Responses to reviewers questions

DAQ design team

CERN, 4th November 2016

ProtoDUNE-SP Organization Chart

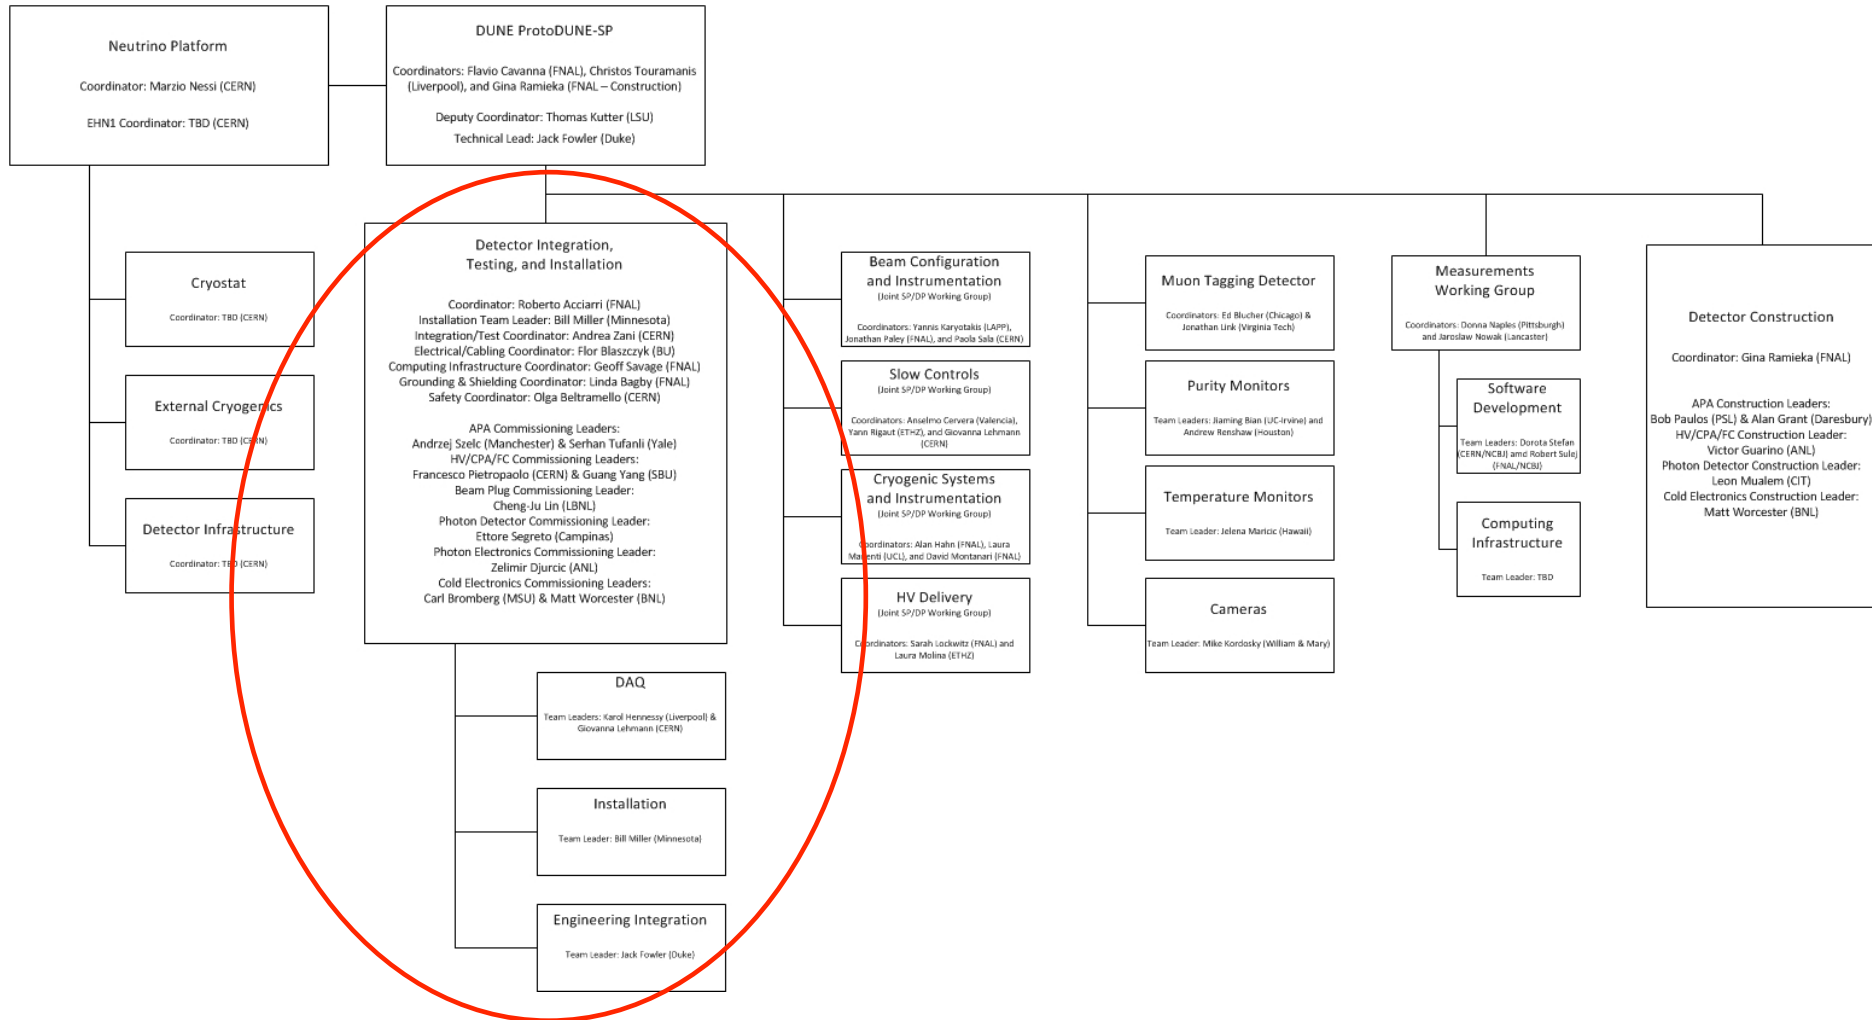
1. Produce an orgchart with leadership & person power in each box -is there a steering group?

See next slides

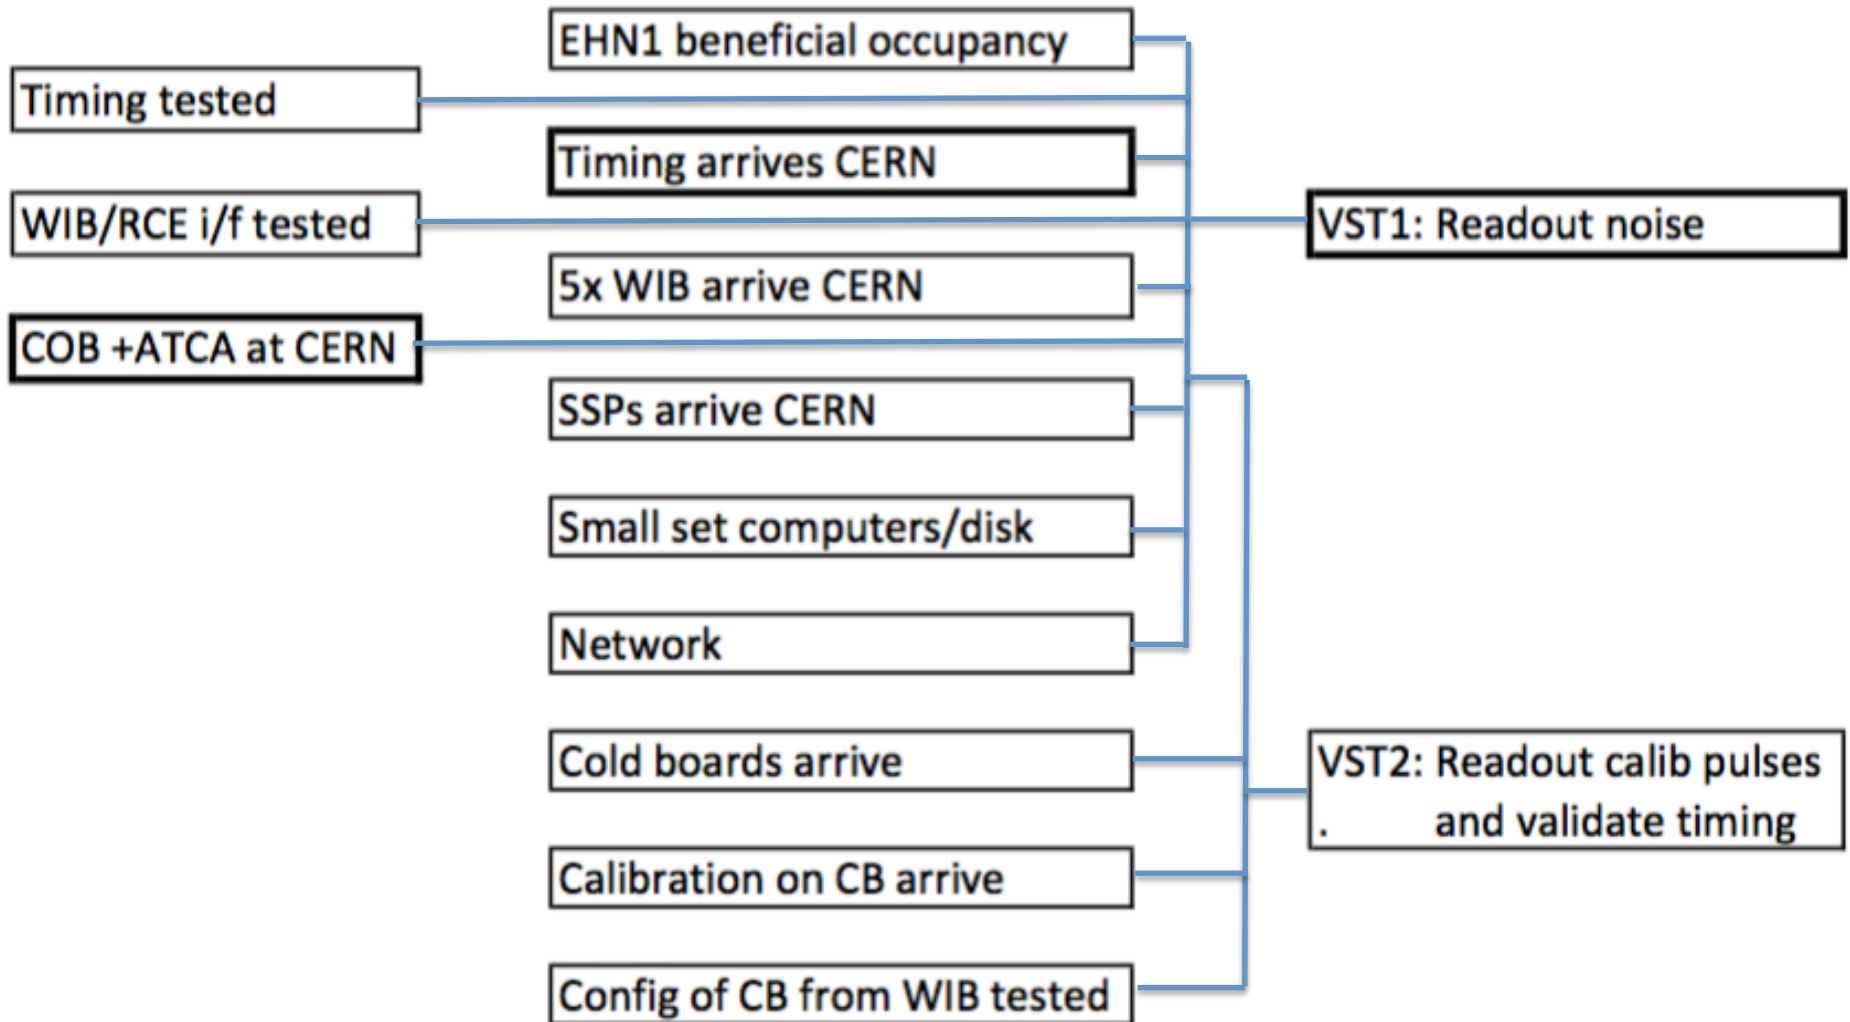
2. Produce a global diagram (with tables if needed) with all links, boxes, bandwidths etc.

Bandwidth displayed from view of main switch

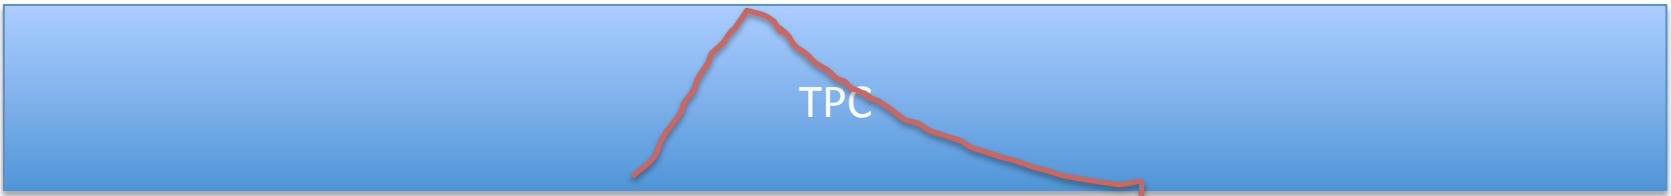
6. How much data can the system take from SSP for full waveform/continuous readout around a beam trigger

- 1.1Gbit/s is used to read out all the headers based on the rates we have been given.
- If we allocate a further 0.1Gbit/s to the photon detector readout, the size of the waveform that could be read on every channel is 6 μ s.
- We consider 2Gbit/s from the SSPs a manageable amount of data that we can afford to collect in normal data taking mode.
- For special runs, much more bandwidth can be allocated to the photon detectors, so we should be able able to take data for much longer.5.

Figure 4.12: Main DAQ steps displayed relative to the event time.

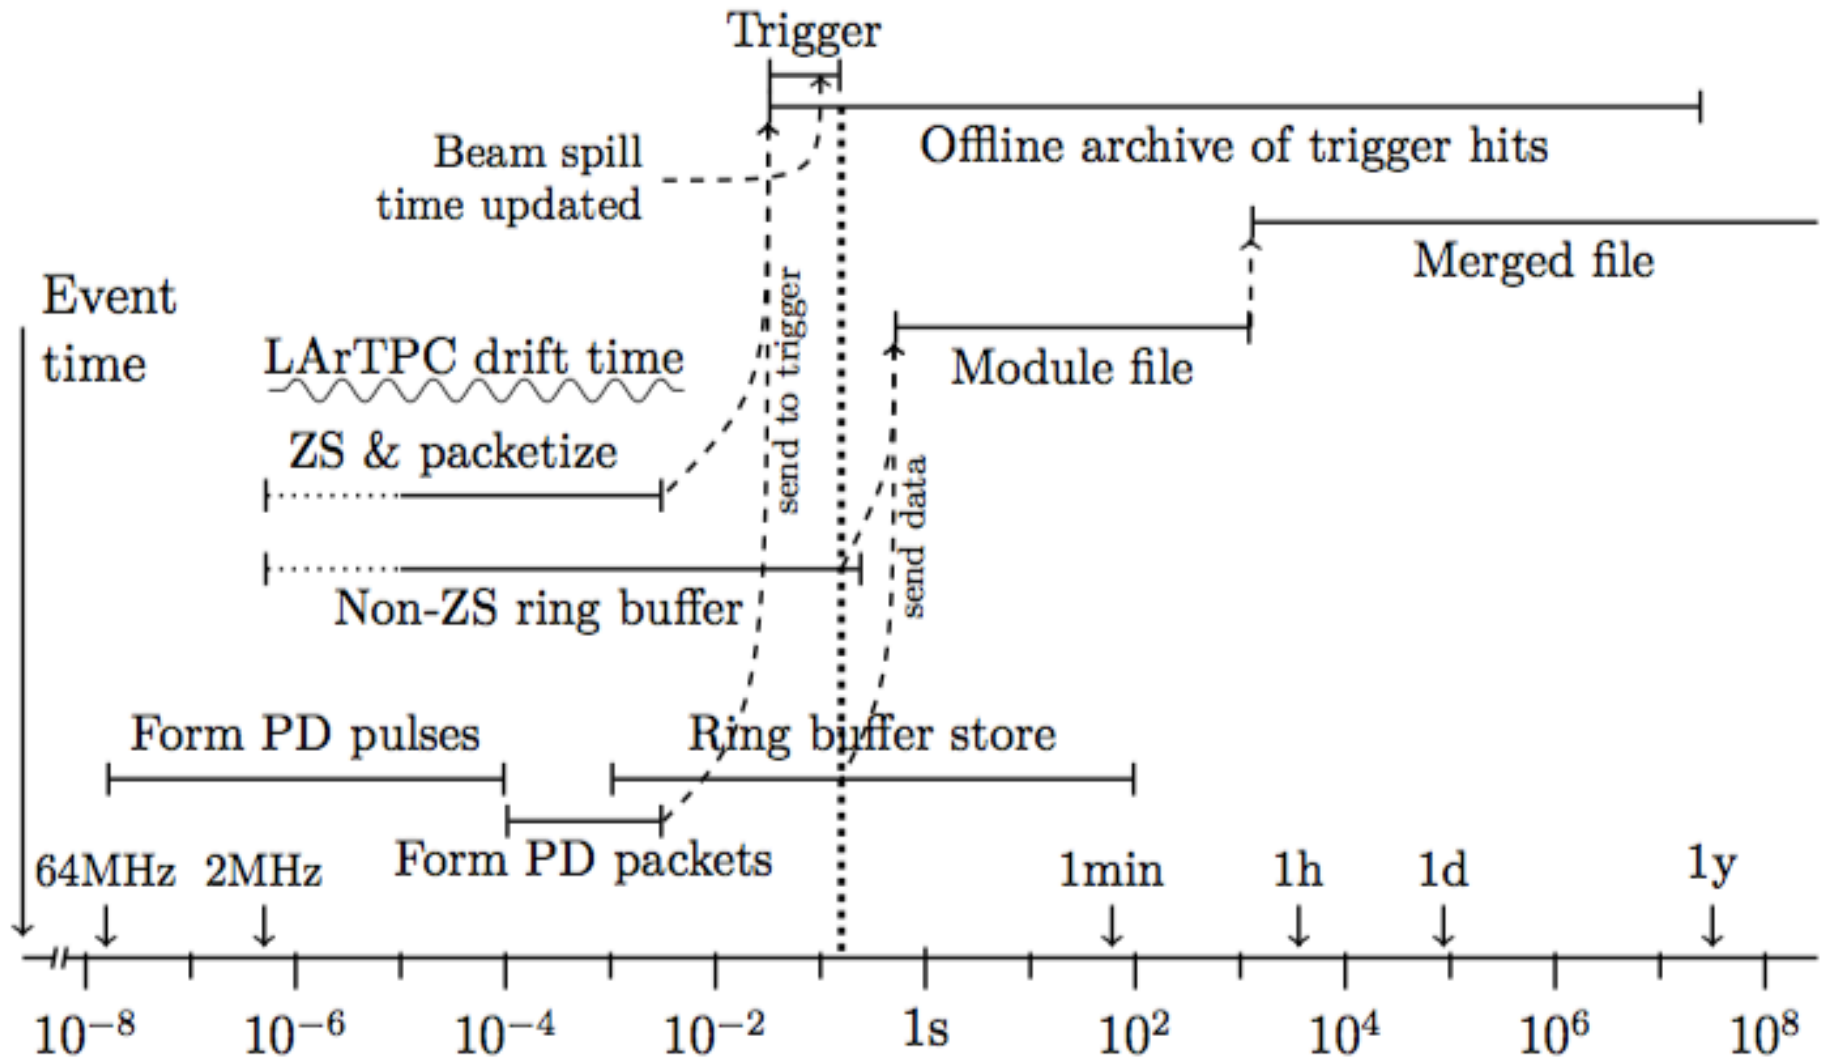
5. Timing diagram showing tolerances, also showing where timestamps get put in, how things get aligned

- In ProtoDUNE, since the headline numbers (5ms drift, 2MHz digitization) are much slower than a normal detector, this is exceptionally easy.
- The latencies of the incoming trigger decisions and data arrival times are fixed and are very small compared to this.
- So alignment is done by
 1. Establishing a clean trigger from the beam (coincidence of two beam counters)
 2. Collect data with TPC and photon system. Measure drift distance of start of track (we need to do this to about 1ms accuracy which is easy), use this to verify that track ends appear in correct location in detector and correct if necessary
 3. This also requires drift velocity measurement, obtained by cosmic tracks passing from cathode to anode plane
 4. By averaging over several events, look for accumulation of photon detector hits in the expected time bin in SSPs or nearby.
